PIC24FJ256GA110 Family Silicon Errata and Data Sheet Clarification

The PIC24FJ256GA110 family devices that you have received conform functionally to the current Device Data Sheet (DS39905E), except for the anomalies described in this document.

The following typographic corrections and clarifications are to be noted for the latest version of the device data sheet (DS39905E):

FIGURE 2-3 FREQUENCY vs. ESR PERFORMANCE FOR SUGGESTED VCAP

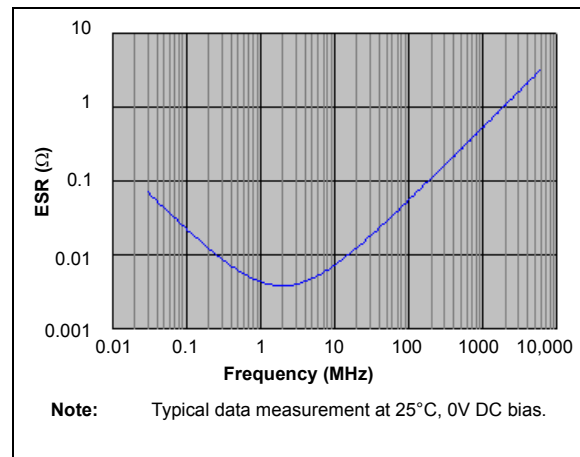
Section 2.4 Voltage Regulator Pins (ENVREG/DISVREG and VCAP/VDDCORE) has been replaced with a new and more detailed section. The entire text follows:

When the regulator is enabled, a low-ESR ($< 5\Omega$) capacitor is required on the VCAP/VDDCORE pin to stabilize the voltage regulator output voltage. The VCAP/VDDCORE pin must not be connected to VDD and must use a capacitor of 10 μF connected to ground. The type can be ceramic or tantalum. Suitable examples of capacitors are shown in [Table 2-1](#). Capacitors with equivalent specifications can be used.

Designers may use [Figure 2-3](#) to evaluate ESR equivalence of candidate devices.

FIGURE 2-4 DC BIAS VOLTAGE vs. CAPACITANCE CHARACTERISTICS

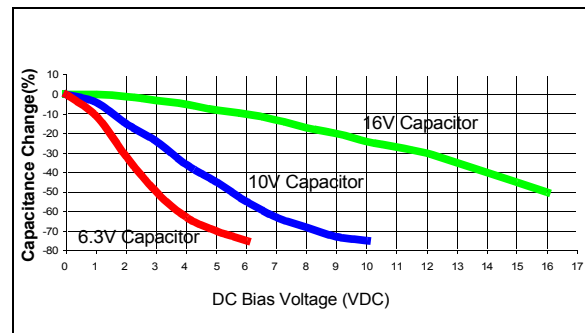
In addition to temperature tolerance, the effective capacitance of large value ceramic capacitors can vary substantially, based on the amount of DC voltage applied to the capacitor. This effect can be very significant, but is often overlooked or is not always documented.

A typical DC bias voltage vs. capacitance graph for 16V, 10V and 6.3V rated capacitors is shown in Figure 2-4.

When selecting a ceramic capacitor to be used with the internal voltage regulator, it is suggested to select a high-voltage rating, so that the operating voltage is a small percentage of the maximum rated capacitor voltage. For example, choose a ceramic capacitor rated at 16V for the 2.5V core voltage. Suggested capacitors are shown in Table 2-1.
